**ZONING AMENDMENT &  
SUBDIVISION STAFF REPORT****Date: November 15, 2018**

<b><u>DEVELOPMENT NAME</u></b>	RJG Real Estate & Development
<b><u>SUBDIVISION NAME</u></b>	The Arbors at Somerby Park Subdivision, Addition to
<b><u>LOCATION</u></b>	(Northwest corner of Cody Road South and Somerby Drive).
<b><u>CITY COUNCIL DISTRICT</u></b>	District 6
<b><u>PRESENT ZONING</u></b>	R-1, Single-Family District
<b><u>PROPOSED ZONING</u></b>	B-3, Community Business District
<b><u>AREA OF PROPERTY</u></b>	1 Lot/ 1.85 ± acres
<b><u>CONTEMPLATED USE</u></b>	<p>Subdivision Approval to create one legal lot of record from a metes-and-bounds parcel, Rezoning from R-1, Single-Family Residential to B-3, Community Business District to build a retail/ office building.</p> <p><b>It should be noted, however, that any use permitted in the proposed district would be allowed at this location if the zoning is changed. Furthermore, the Planning Commission may consider zoning classifications other than that sought by the applicant for this property.</b></p>

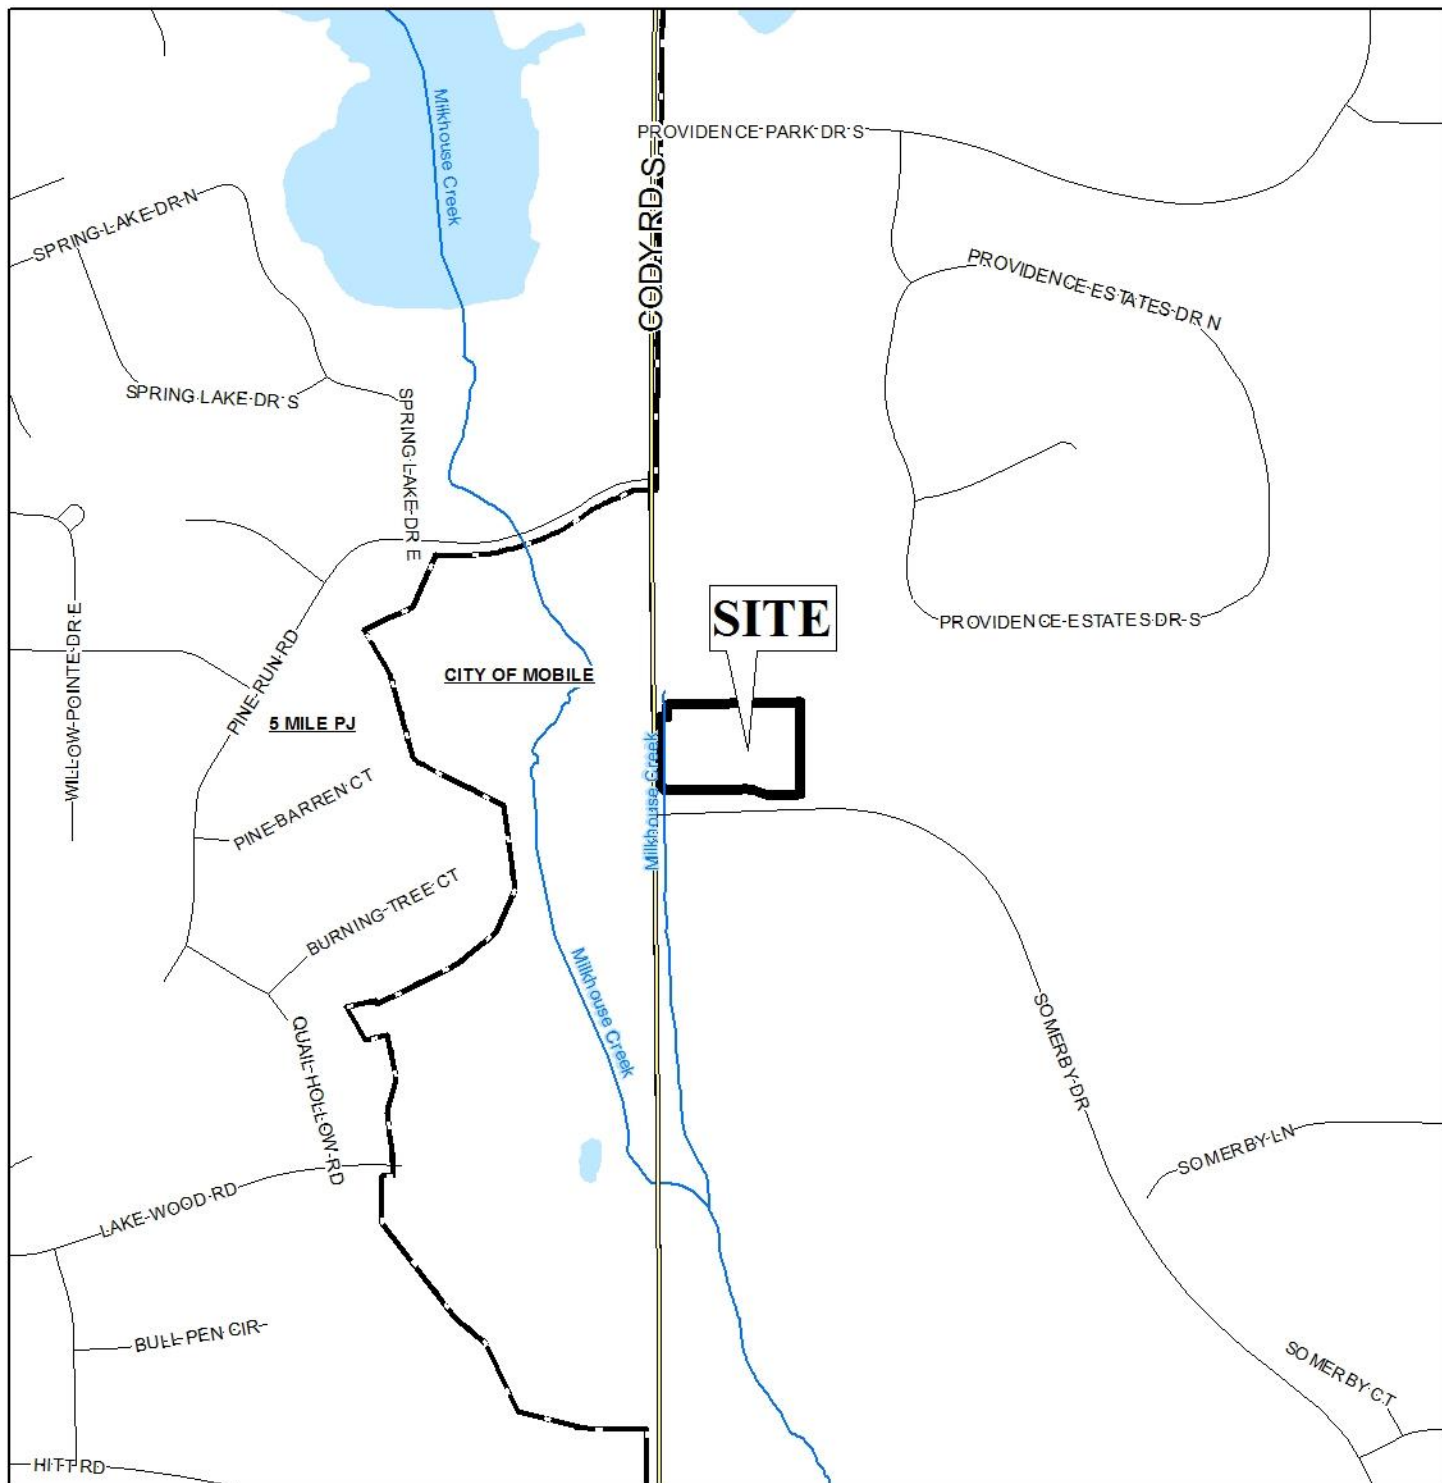
The site has frontage onto two streets Cody Road South and Somerby Drive. Cody Road South is identified as a major street with a 100' right-of-way and Somerby Drive is identified as a minor street with 50' right-of-way. It would appear that sufficient right-of-way may be provided, however, neither the plat nor the site plan depicts the right-of-way widths. Right-of-way dedication along Cody Road was previously required as part of the Providence/ Coley Subdivision, recorded in June 2000 so no additional dedication should be necessary. Somerby Drive was created as part of a 2002 subdivision, thus no additional right-of-way dedication should be necessary. If approved, both the site plan and the plat should be revised to depict the right-of-way widths for both Cody Road South and Somerby Drive.

The lot size is not provided in square feet or acres. If approved, the plat and the site plan must be revised to depict the lot size in both square feet and acres or the provision of a chart depicting that information will be required.

The 25' minimum building setback lines are not depicted on the plat. The plat must be revised to depict the 25' minimum building setback lines where the property abuts street frontage.

There is no indication of a privacy fence or vegetative buffer depicted on the site plan. A protection buffer will be required where the site abuts residentially zoned property.

- 1) revision of the plat to depict the lot size in square feet and acres or the provision of a chart depicting that same information;
- 2) revision of the plat to depict the 25' minimum building setback line along all street frontages;

- 3) revision of the plat to depict the minimum existing right-of-way width along Cody Road South and Somerby Drive;
- 4) placement of a note on the Final Plat stating the lot is denied direct access to Cody Road and limited to the two proposed curb-cut to Somerby Drive with the size, design, and location to be approved by Traffic Engineering and in conformance with AASHTO standards;
